RUTH HARDING SCHOOL MODERNIZATION

ADDENDUM #01

DWG NO. 3

DEMO PLAN/ FLOOR PLAN

DEMOLITION FLOOR PLAN

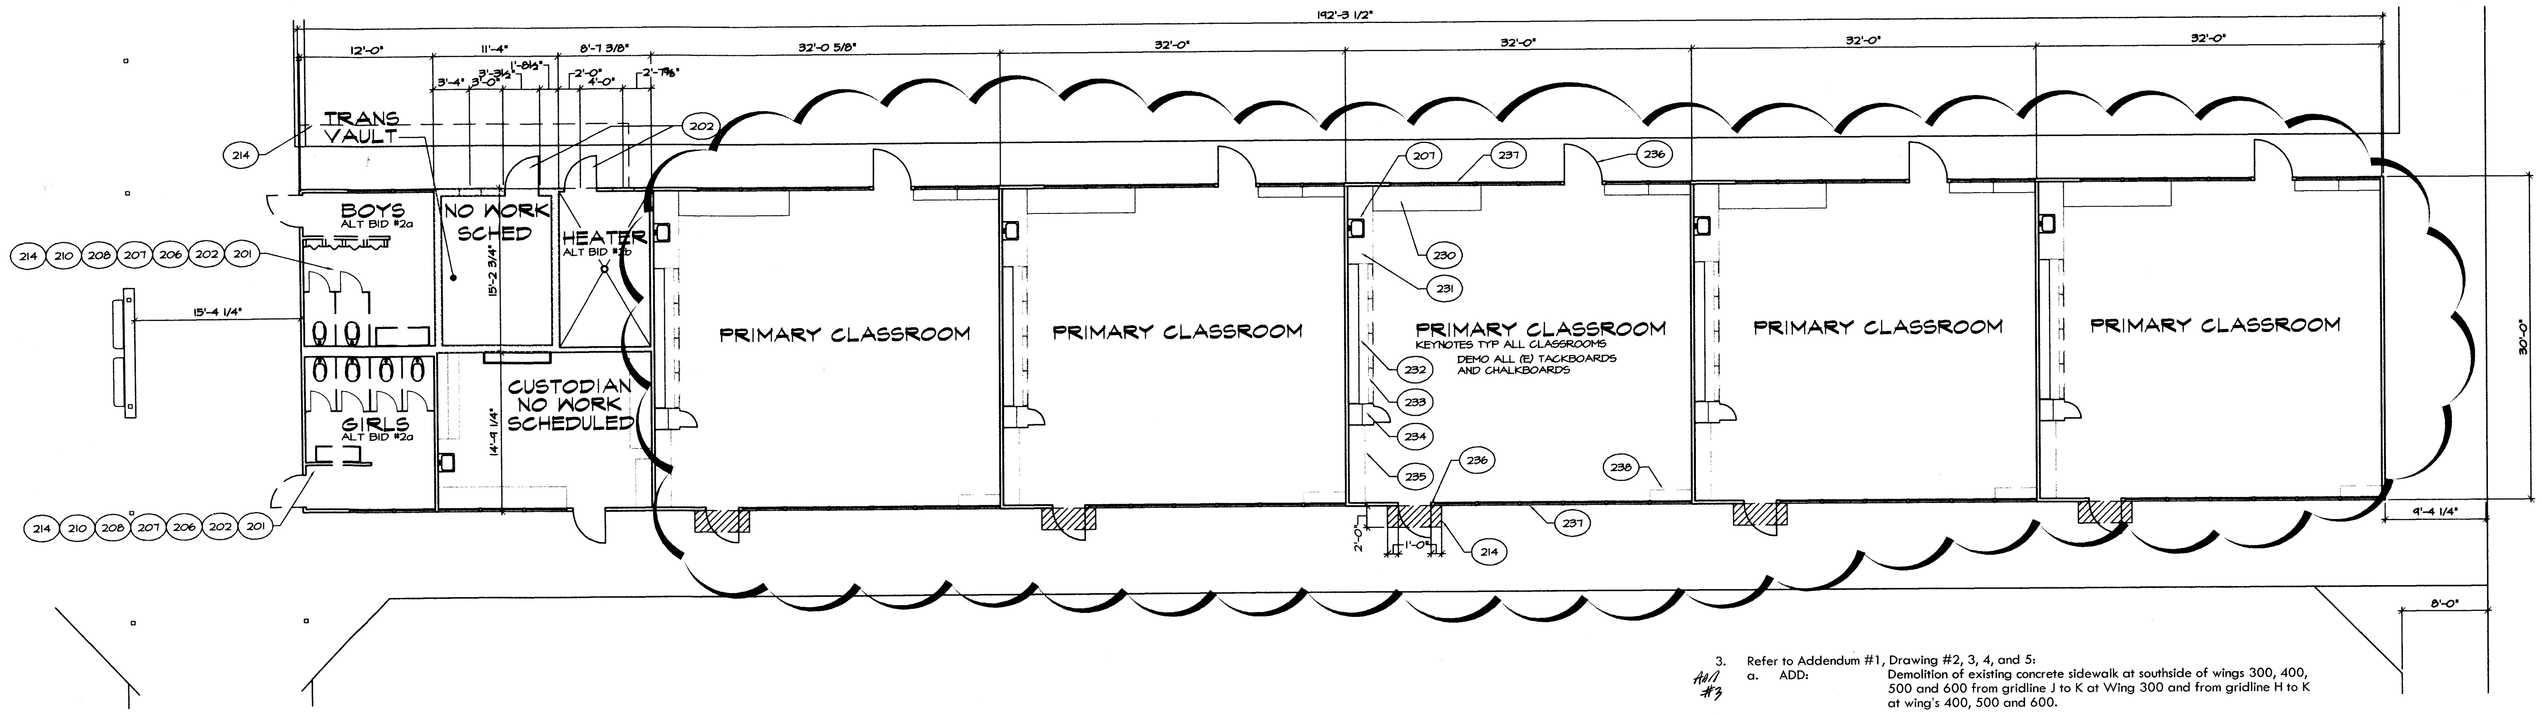
1. Refer to Addendum #1, Drawings Sheet #3, 4, & 5 Floor Plan/Demo Plan Wing 400, 500 & 600:
   a. REVISE: Keynote #231 to read as follows: "Demo existing counter top and base cabinet" Note: This work to be apart of the scope of work.

3. Refer to Addendum #1, Drawing #2, 3, 4, and 5:
   a. ADD: Demolition of existing concrete sidewalk at southside of wings 300, 400, 500 and 600 from gridline J to K at Wing 300 and from gridline H to K at wing's 400, 500 and 600.
   b. ADD: 4" thick concrete walk, 2,500 psi w/ #4 rebar at 24" O.C. each way at center of walk over 4" agg-base compacted to 95% OMC min. over 12" compacted native soil. Walk to be flush with finish floor at doors with a maximum slope of 1:20 between doors and a maximum cross slope of 2% Drill and dowel into existing slab with #4 x 24" dowels @ 24" o.c. drill 5/8" ø hole min. 5" embed epoxy with HILTI HY150.

FLOOR PLAN - WING 400

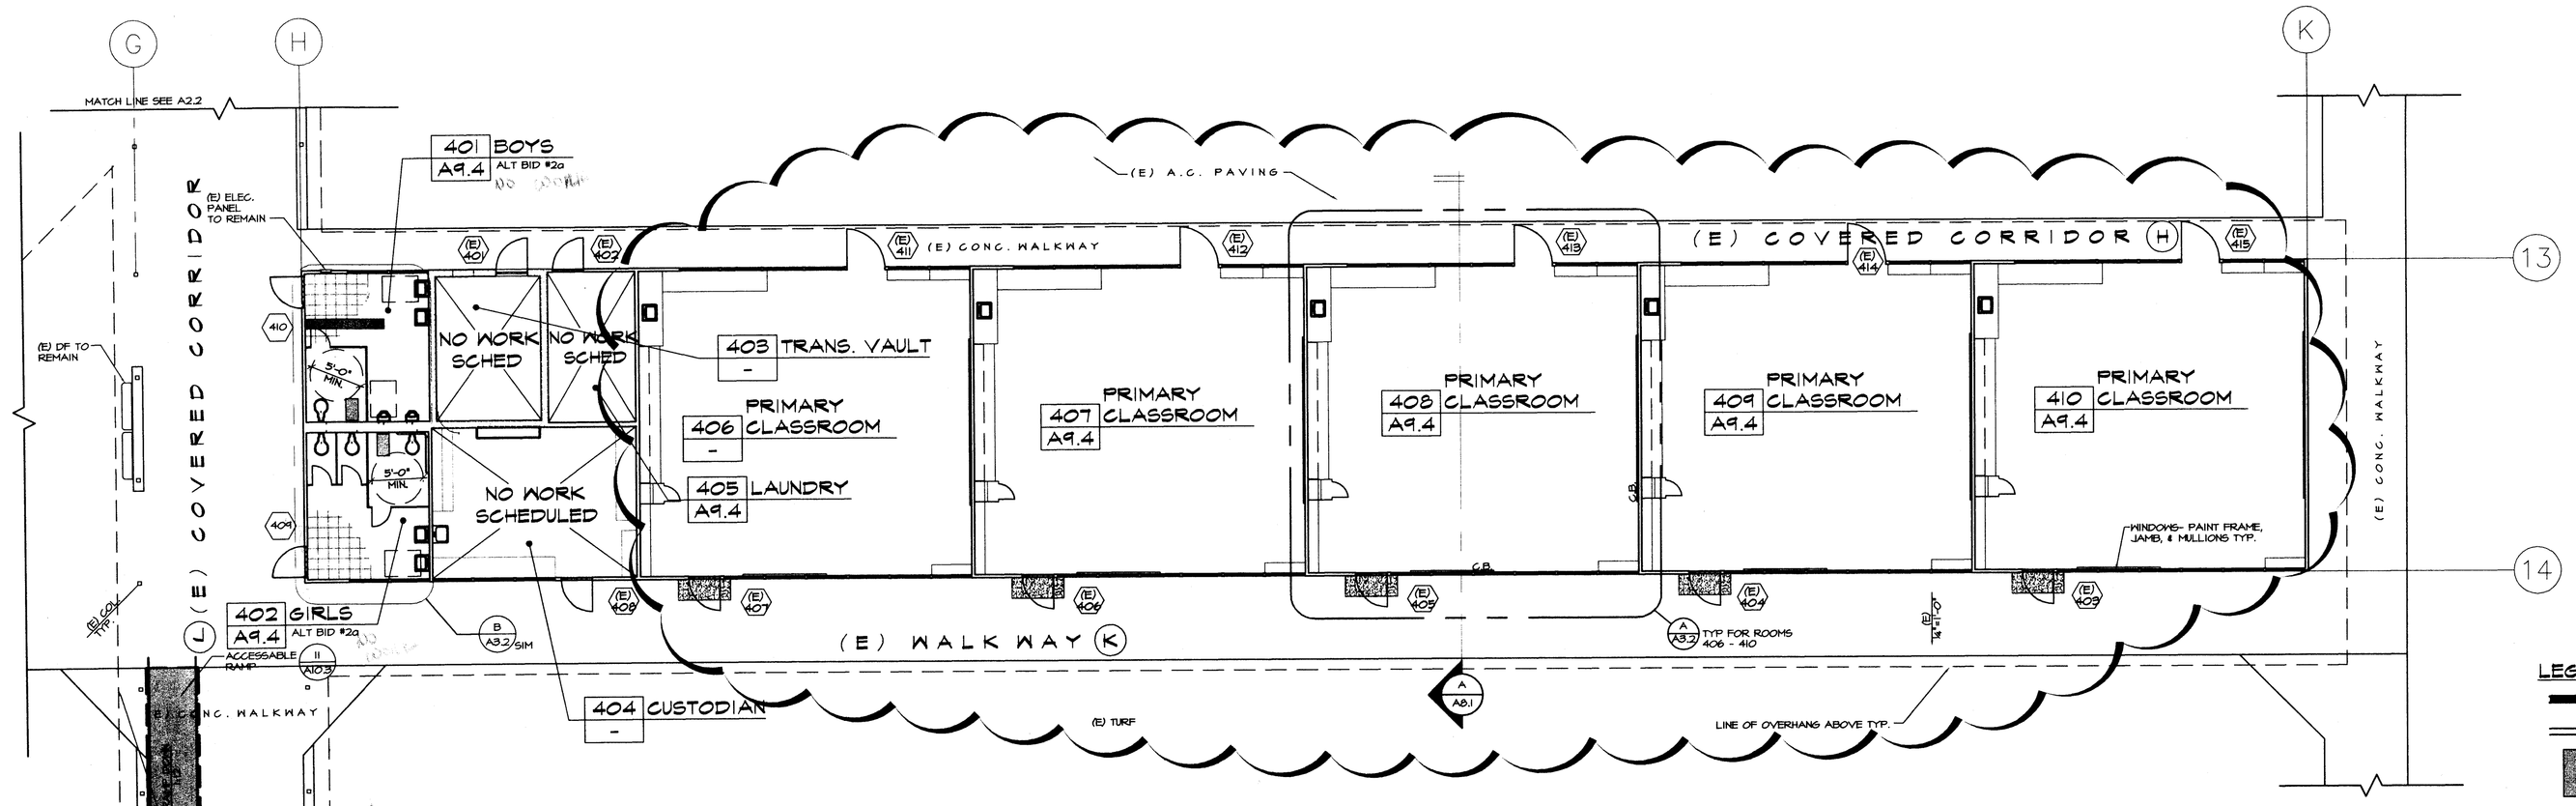
a. DELETE: WORK AS INDICATED FOR ROOMS #401 AND #402
